HISTORIC AND DESIGN REVIEW COMMISSION

May 03, 2017

HDRC CASE NO: 2017-192
ADDRESS: 1025 DAWSON ST
LEGAL DESCRIPTION: NCB 2872 BLK N LOT 6
ZONING: R-6 H
CITY COUNCIL DIST.: 2
DISTRICT: Dignowity Hill Historic District
APPLICANT: Richard Gross
OWNER: Enlour Investments
TYPE OF WORK: Fenestration modifications, wood window replacement
REQUEST:

Dawson Street, lot 6 SOUTH ELEVATION - EXISTING

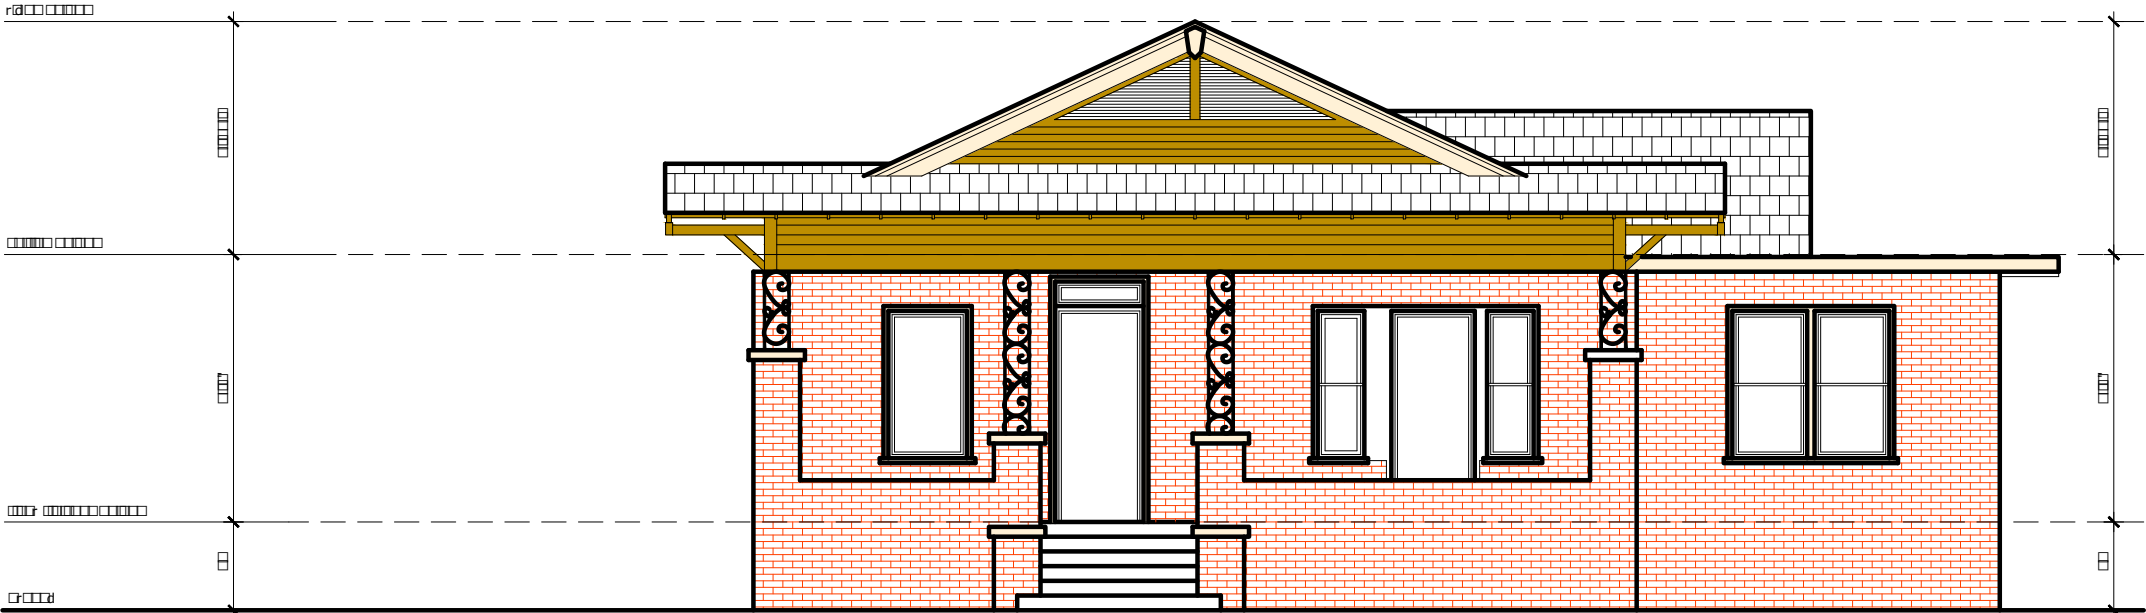
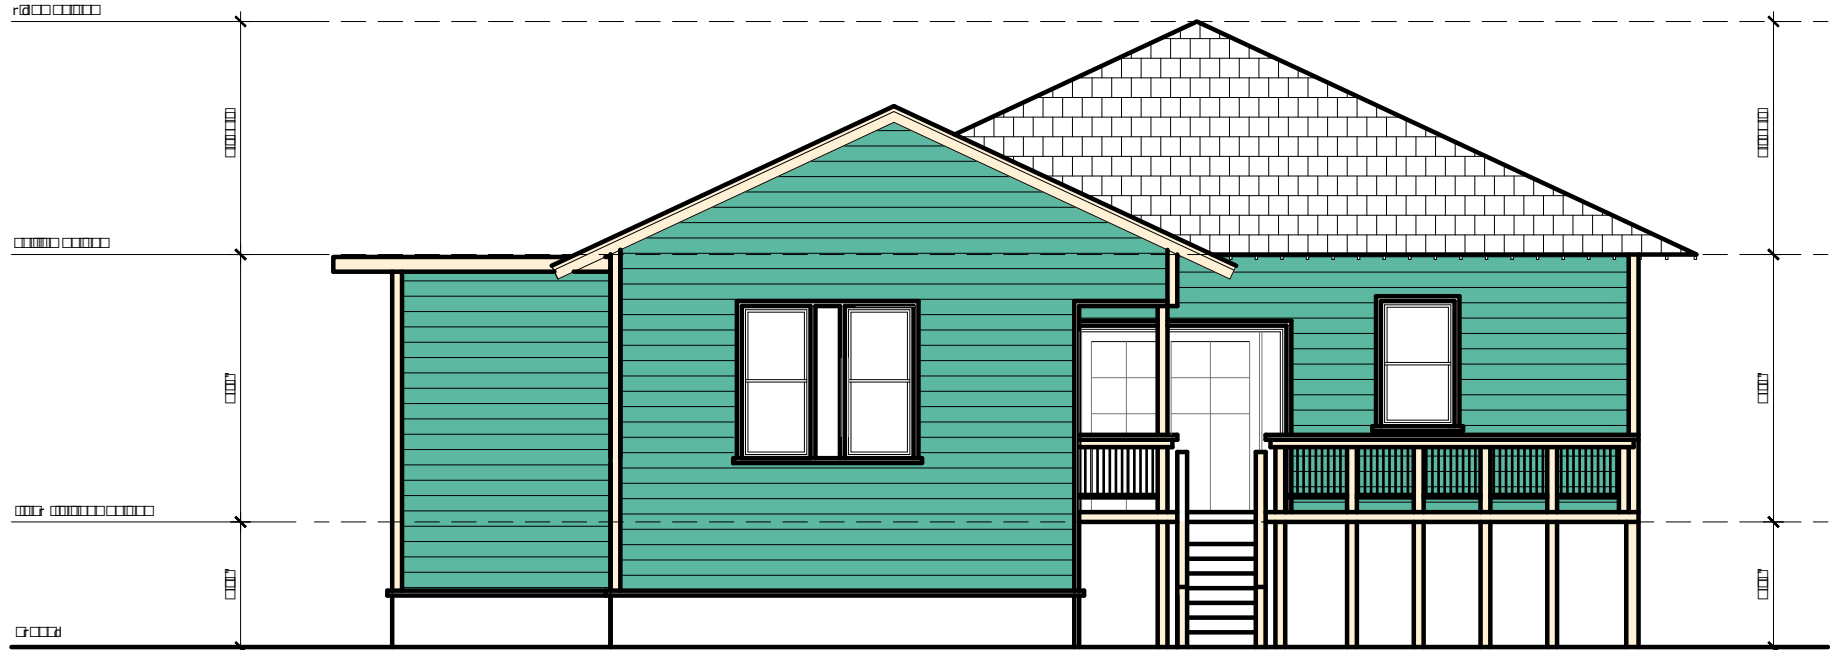
- e. **REAR ADDITION MODIFICATIONS** – The rear of the primary historic structure features an addition with a side (east) facing door. The applicant has proposed to remove this door and install a window in its place that is to match the existing wood windows in the addition in regards to size and profile. Staff finds the proposed modification appropriate given that the addition is not original to the historic structure given its location at the rear of the primary historic structure and its differing roof form. Additionally, this addition is not found on the 1912 or 1951 Sanborn maps. The applicant should install a window that features a matching profile to that of the rear addition as well as one that is consistent with the Historic Design Guidelines, Window Policy Document that is to include traditional dimensions and profiles, be recessed within the window frame, feature traditional materials or appearance and feature traditional trim and sill details. If the windows that will be removed from the side addition are matching in size as those on the rear addition, they should be installed in place of the existing door.

Staff does not recommend approval of items #1 and #2 based on findings b and e. Staff recommends the applicant maintain the rear façade arrangement and repair the existing windows.

Dawson Street, lot 6 NORTH ELEVATION - EXISTING

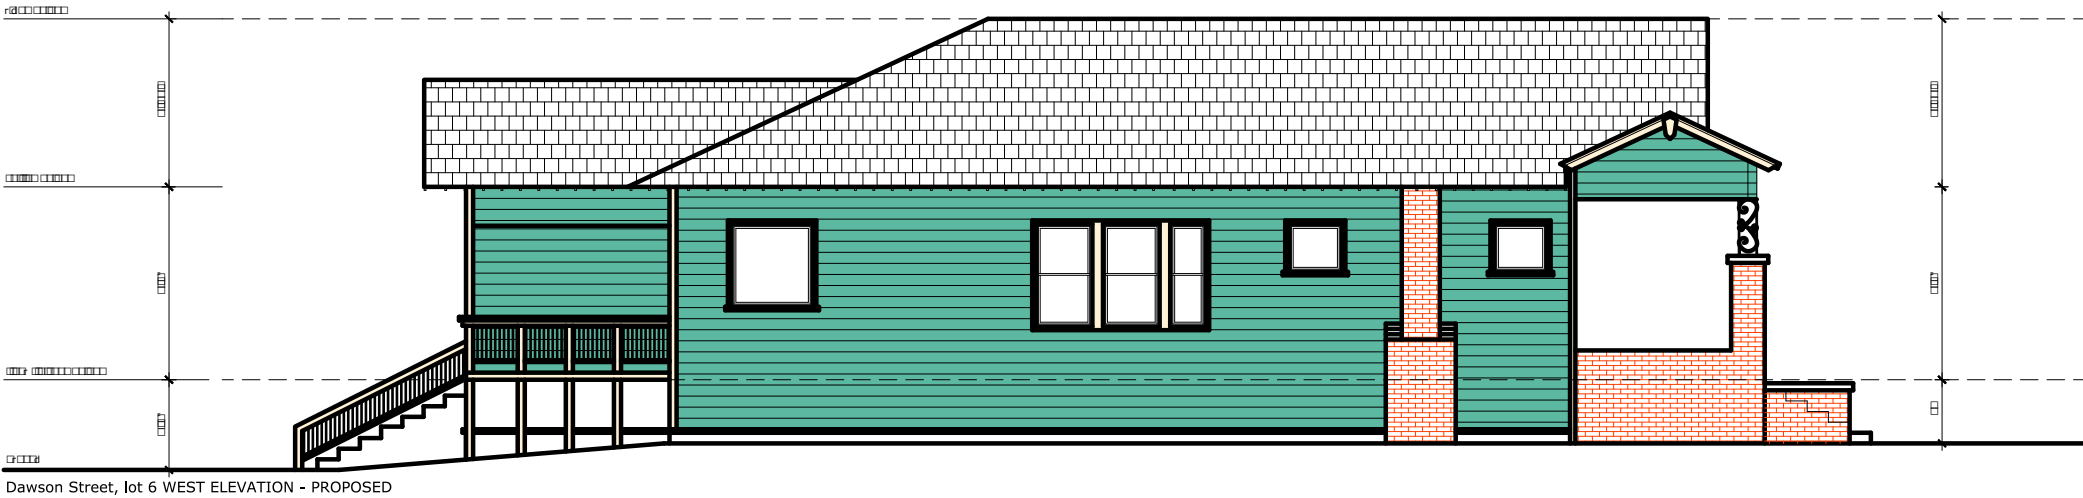
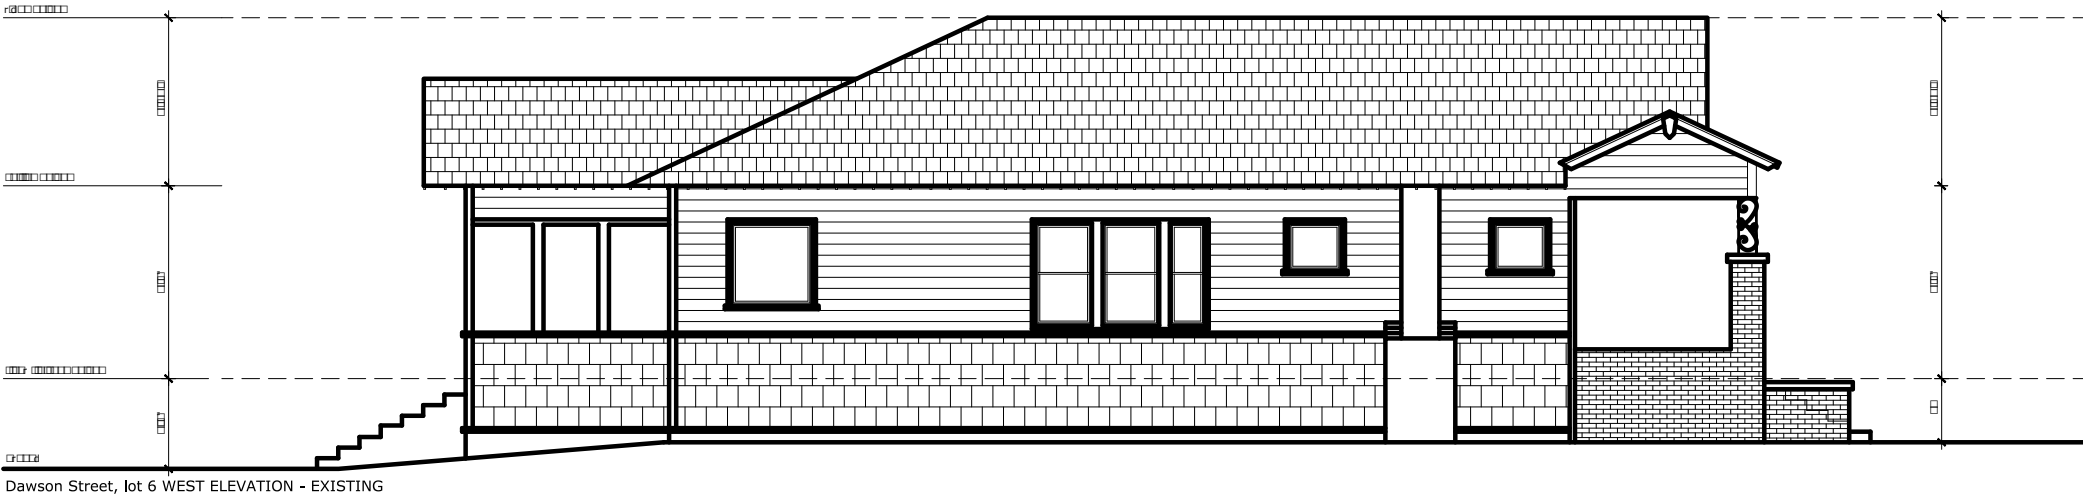
- b. **REAR FAÇADE MODIFICATIONS**— On the rear façade, the applicant has proposed to modify an existing door and window opening. The proposed modification is to occur on the rear façade of the original structure. Per the Guidelines for Exterior Maintenance and Alterations 6.A.1., historic window and door openings are to be preserved and should not be enlarged or diminished. The proposed modifications are not consistent with the Guidelines.

- c. **SIDE ADDITION MODIFICATIONS**— The applicant has proposed to enclose two existing openings on the side addition, one which faces the east and one which faces the north. The existing side addition features a roof slope that is not consistent with the original structure and also features materials that are not consistent with those found predominantly on the original structure. Modifications to the original structure including front porch modifications contain materials commonly used during the 1950's.

- d. **SIDE ADDITION MODIFICATIONS** – Per the Guidelines for Exterior Maintenance and Alterations 6.A.1., historic window and door openings are to be preserved. Staff finds the removal of the rear facing window appropriate given its location on a rear facing façade; however, staff finds that the existing side window is to remain. Structures located within historic districts typically do not feature entire wall planes that lack fenestration.

Staff does not recommend approval of item #4 based on finding d.

Staff recommends approval of items #3 and #5 based on findings c and d.
